ADDENDUM NO. 1

RE: Item #2, December 11, 2024 Letting - 436 (), PCN X05W, Hughes County - Water Main Improvement and Sewer Manhole Adjustments

PLANS: Please destroy sheets D.1, D.2, D.3, D.4, I.5, I.12, I.13, I.19 & N.1 and replace with the enclosed sheets, dated 11/21/24.

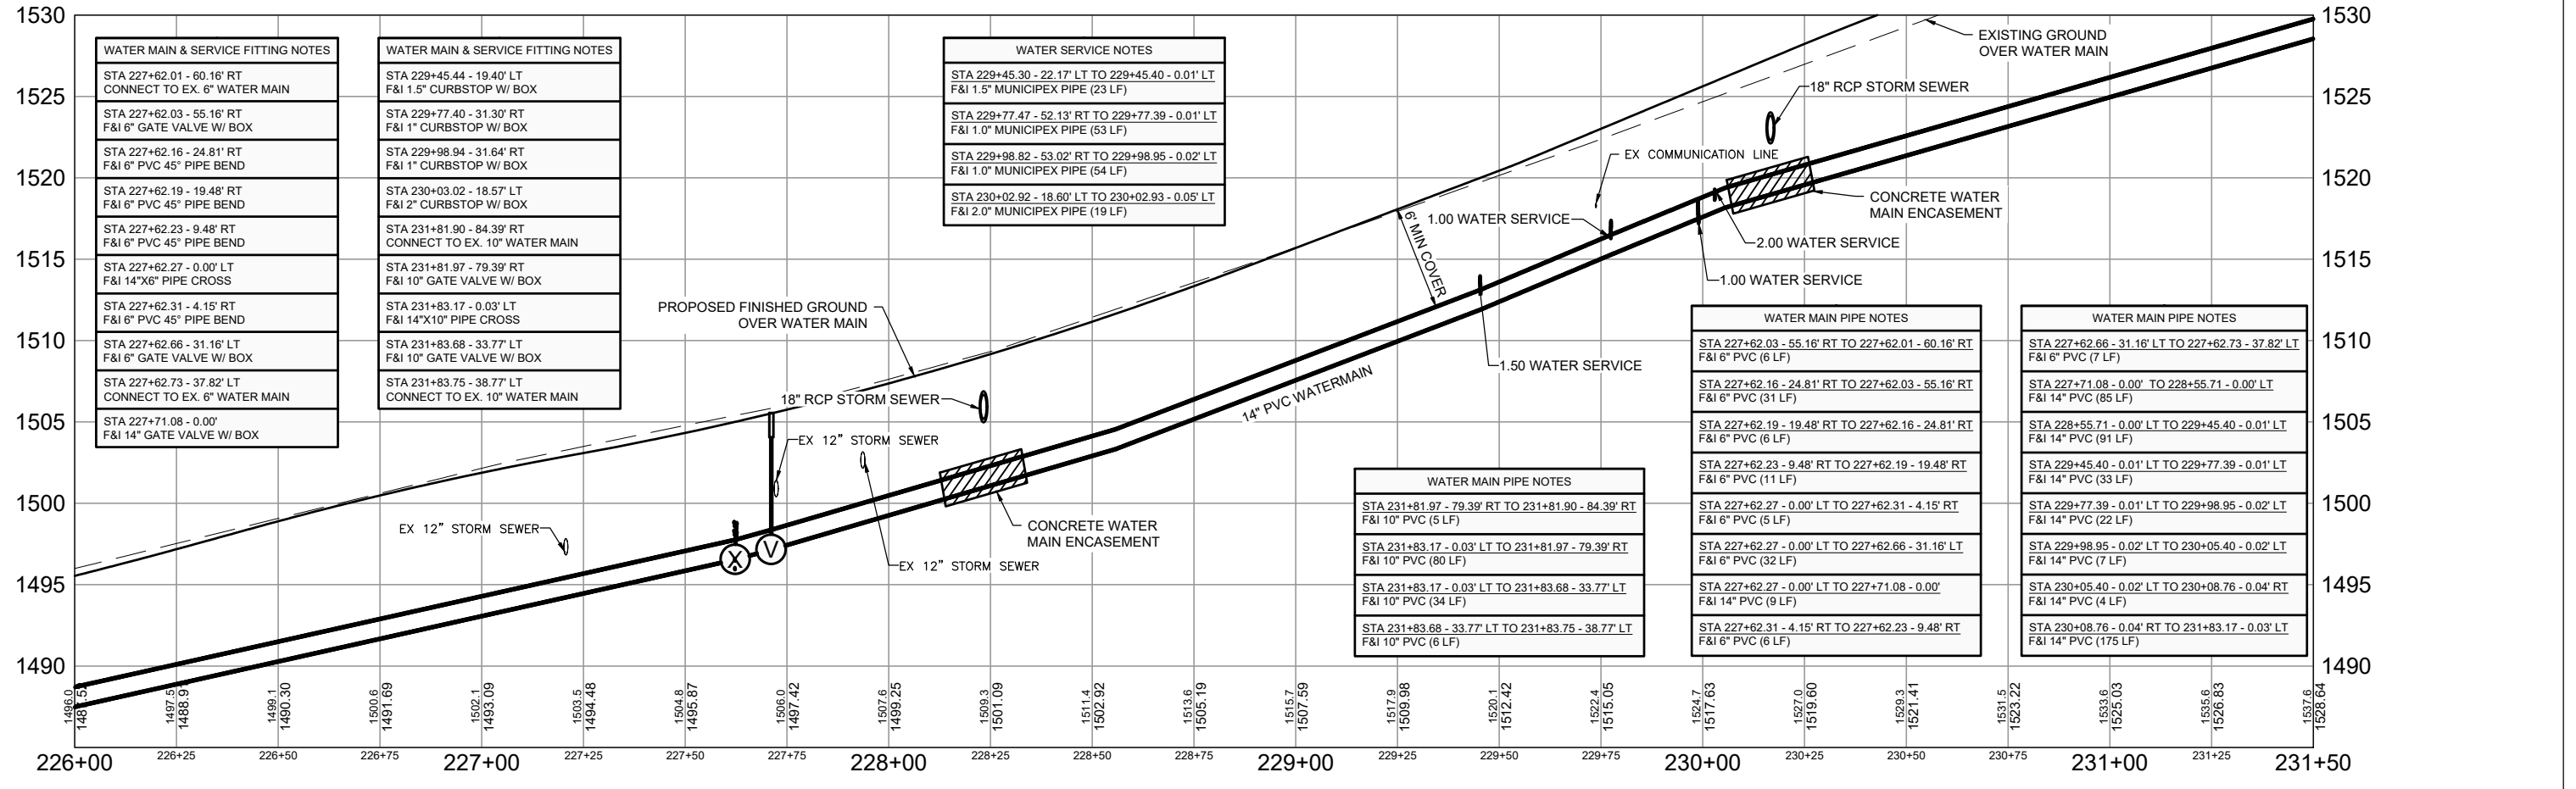
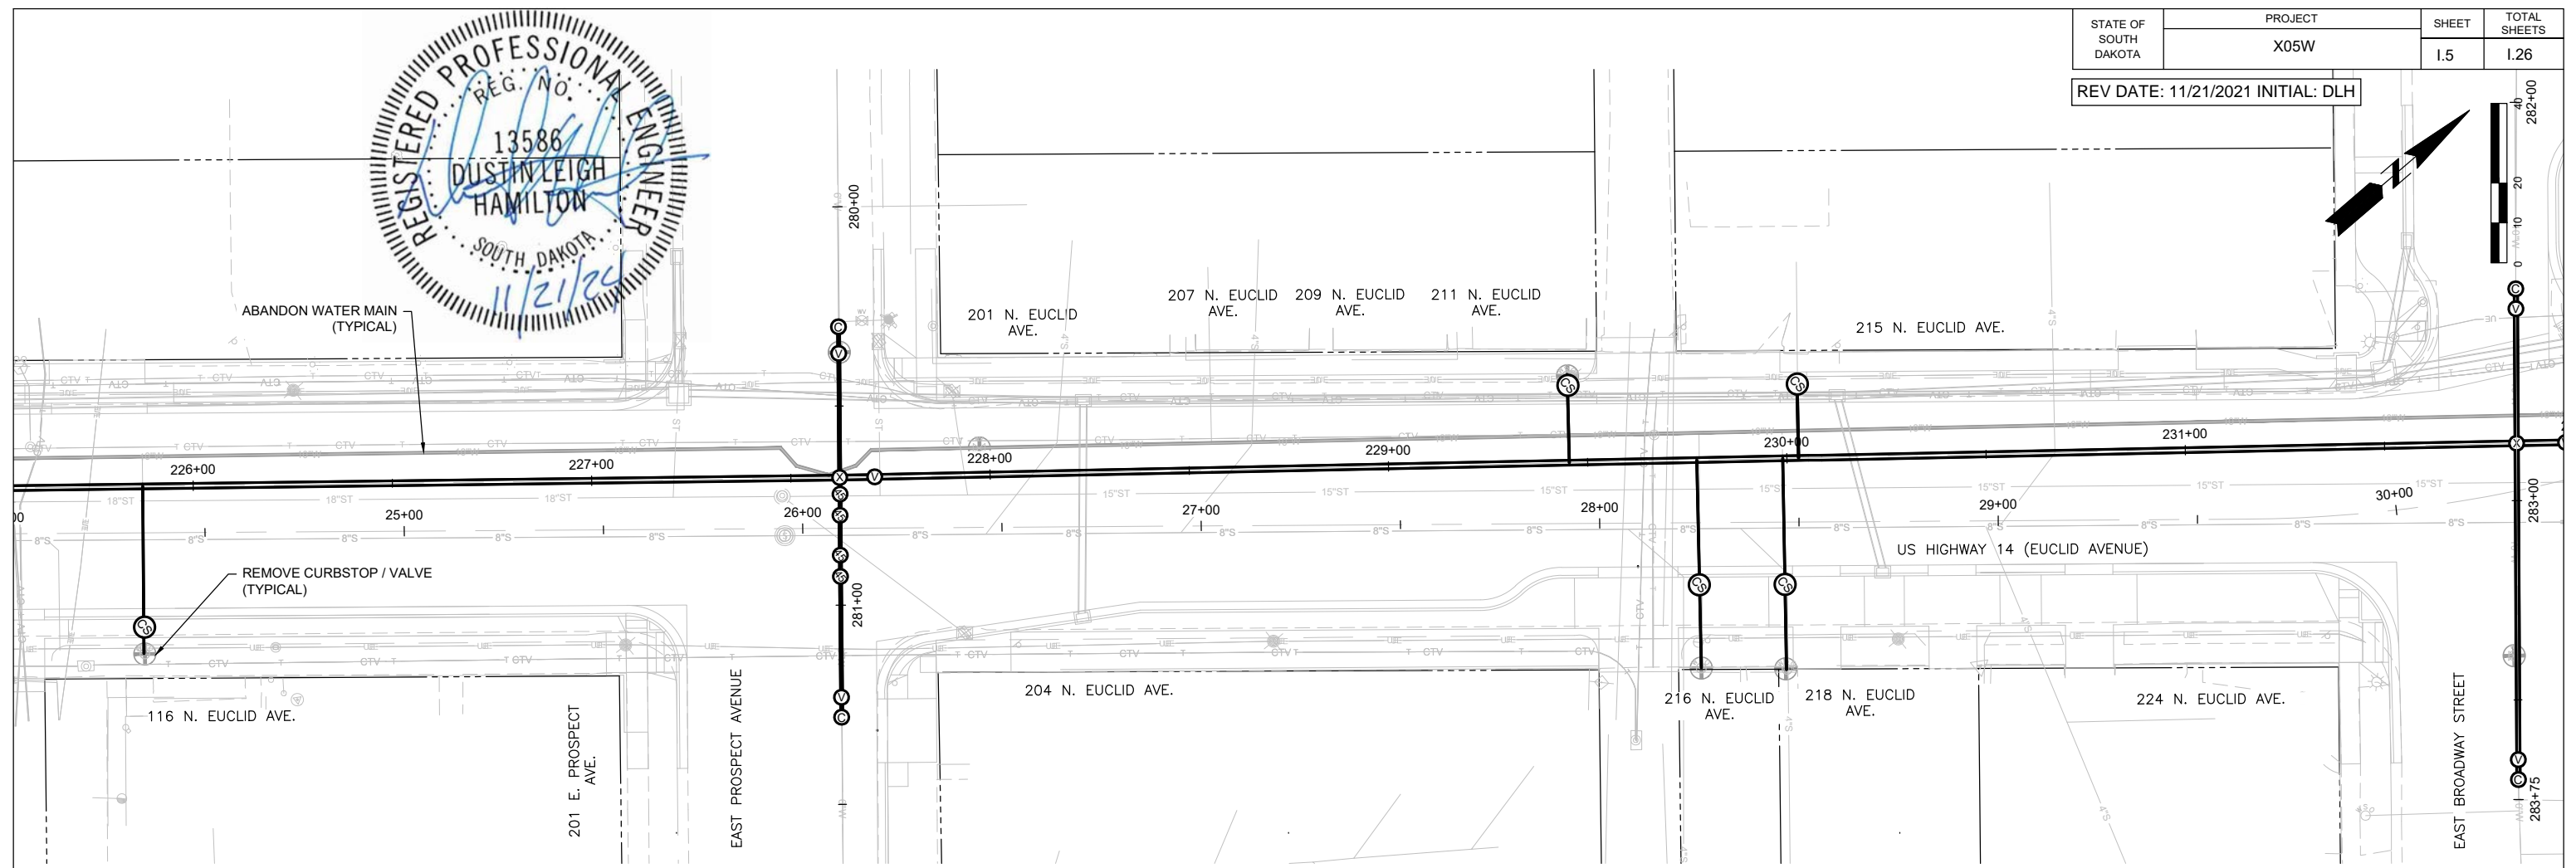
Sheet I.5: Water service size and locations were revised.

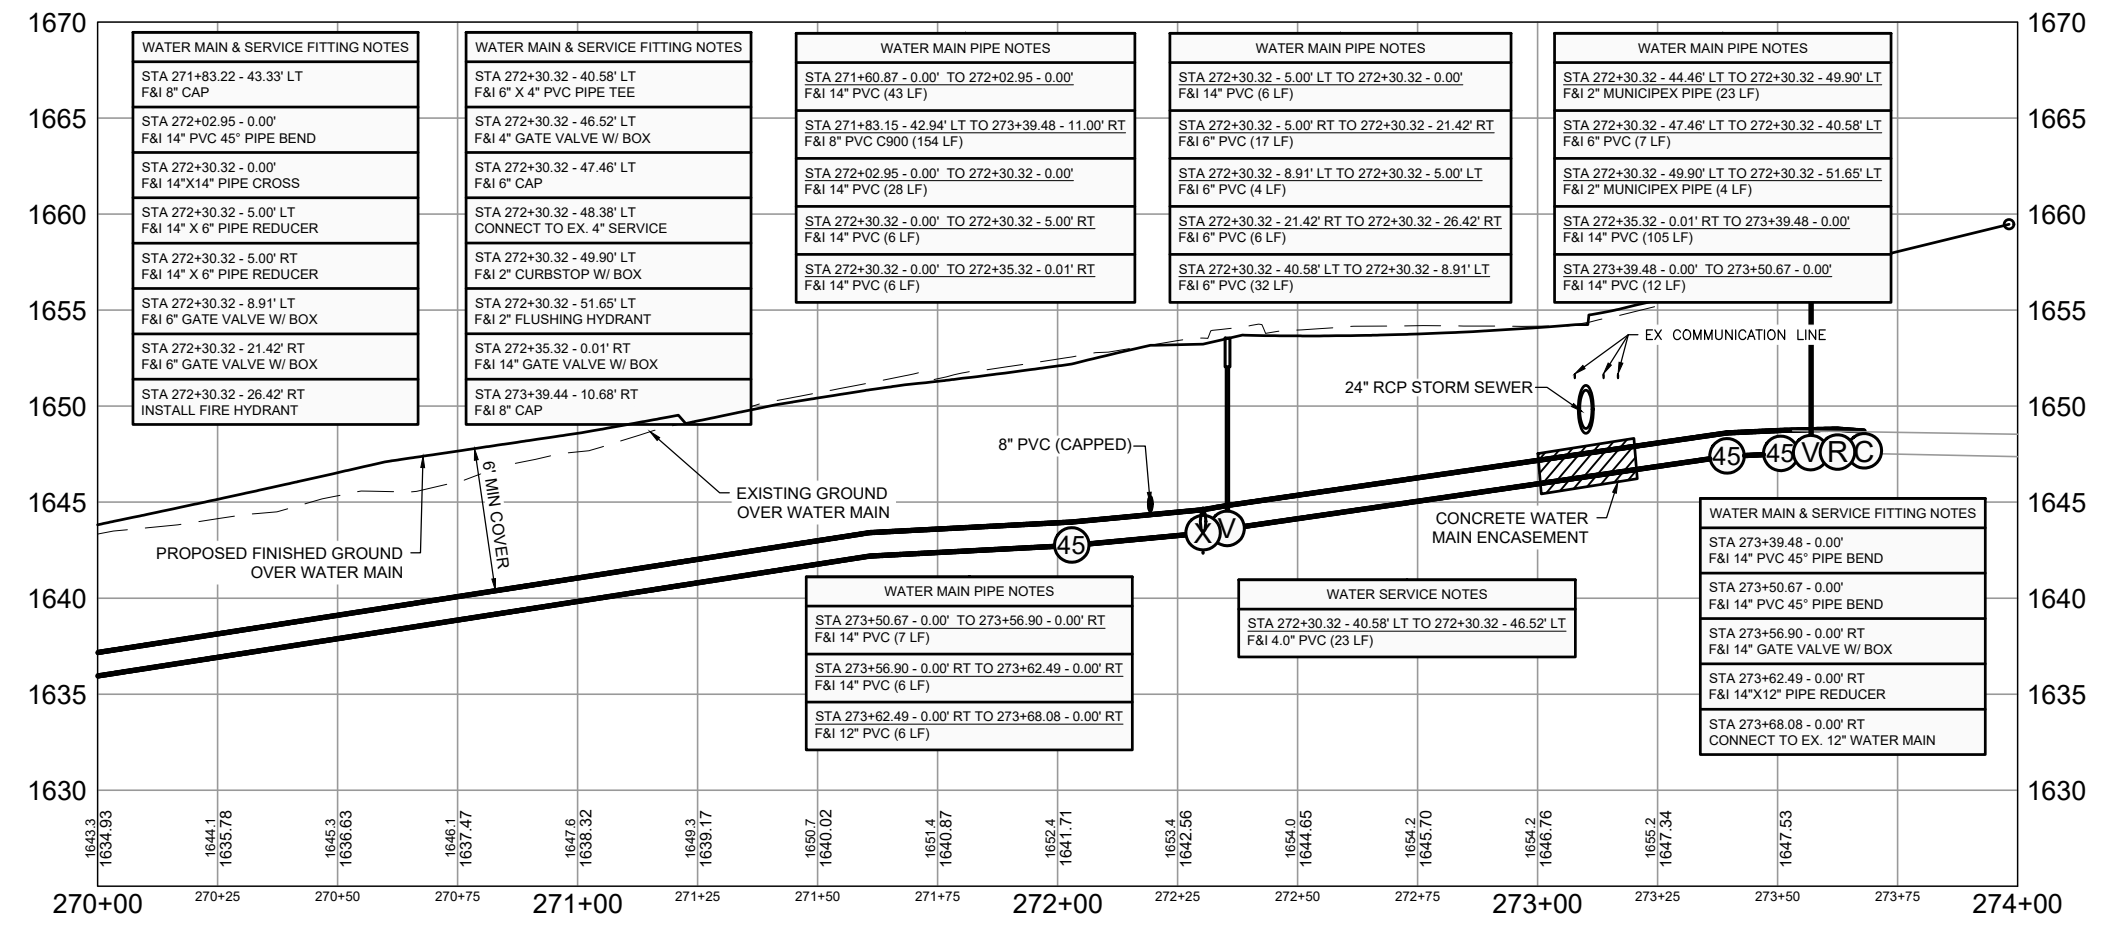
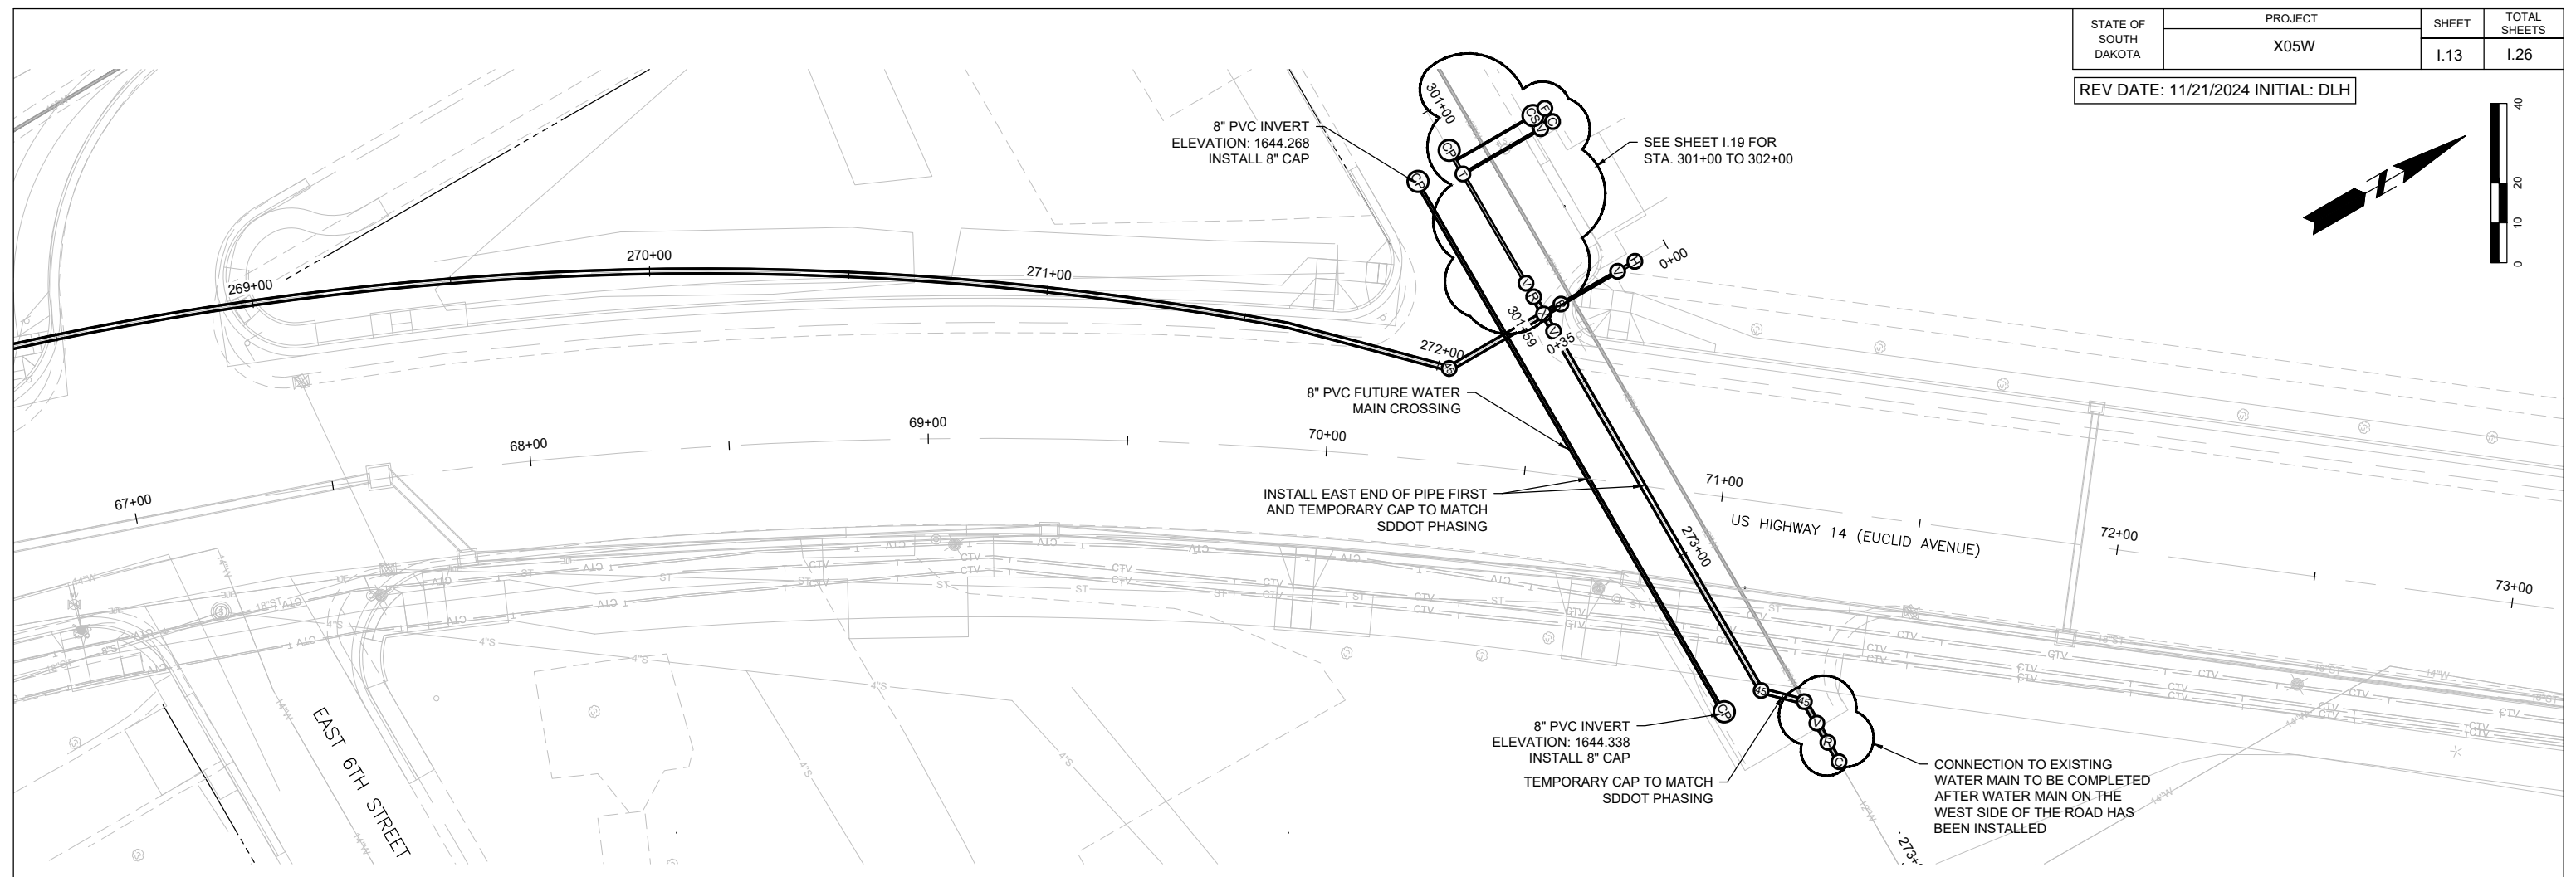
Sheets I.13 & I.19: Connection to existing water main was removed at Sta 272+30.32. 6" cap and flushing hydrant was added. Replaced 16" steel casing pipe with 8" PVC and caps.

FLUSHING HYDRANT

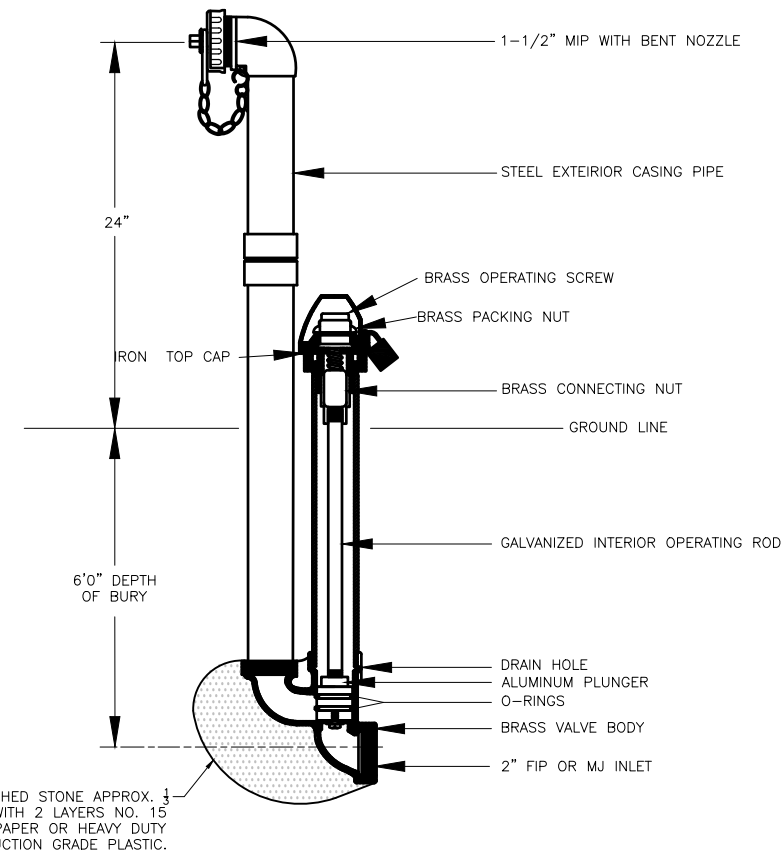
FLUSHING HYDRANT detail was added.
